CORRIGENDUM

Ref. Sales No. E.08.VIII.4 (ECE/TRANS/203, Vol. I and II)

EUROPEAN AGREEMENT CONCERNING
THE INTERNATIONAL CARRIAGE OF
DANGEROUS GOODS BY INLAND WATERWAYS (ADN)
(2009 version of the Annexed Regulations)

Corrigendum

2. 2.2.9.1.10.4 Classification flowchart for environmentally hazardous substances

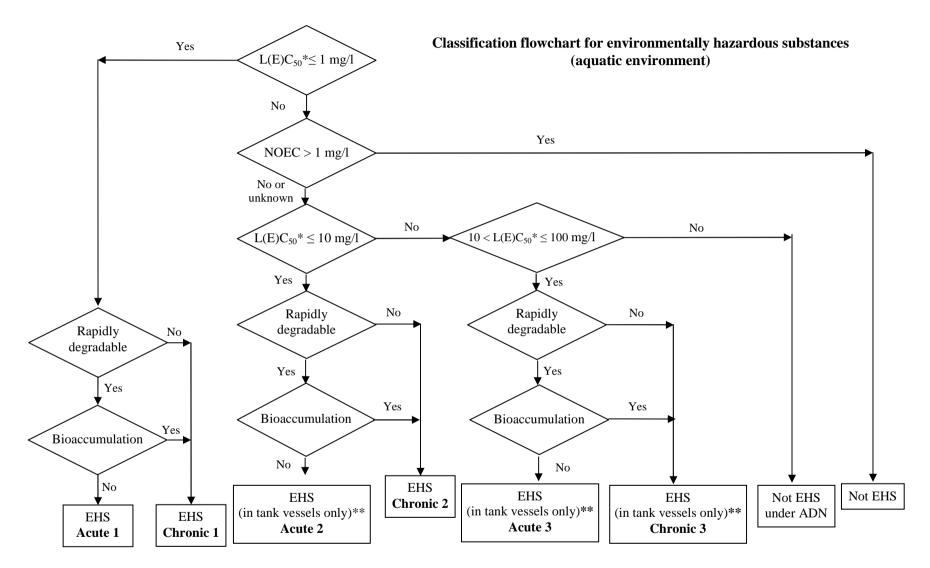
Replace flowchart by the flowchart at the end of the present corrigendum
